# TECHNICAL BULLETIN

## Clutch Hydraulic Hose – Install Protective Sleeve – Service Action S 452

MODEL XJS (4.0L) Range 1994 MY

Service Action S452

ILLUSTRATION 1

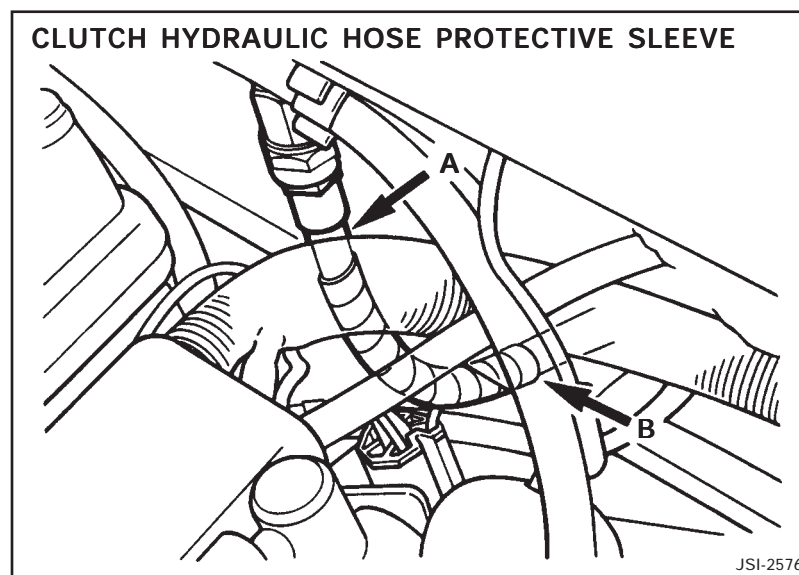
Some 4.0L XJS Range manual transmission vehicles within the above VIN range may experience interference between the clutch hose and the bulkhead heatshield. This condition may lead to abrasion of the clutch hydraulic hose.

Inspect the hose at the next service opportunity or in the event of a customer complaint. On all vehicles, install a protective sleeve over the clutch hose as described below. Replace the clutch hose if abrasion has occurred.

1. Examine the clutch hydraulic hose between points A and B, Illustration 1. Check for signs of abrasion caused by contact with the bulkhead heat shield.
2. If **any** visible abrasion is found, replace the clutch hydraulic hose, bleed the clutch hydraulic system, and top up the fluid level as needed. If **no** abrasion is found, proceed to step 3.
3. On all vehicles, wrap the spiral protective sleeve (part number CCC 5388) around the existing or replacement clutch hydraulic hose from point A, the bulkhead attachment point, to point B where the rubber sleeve starts. Apply the wrapping so that no part of the flexible hose remains visible between points A and B, Illustration 1.
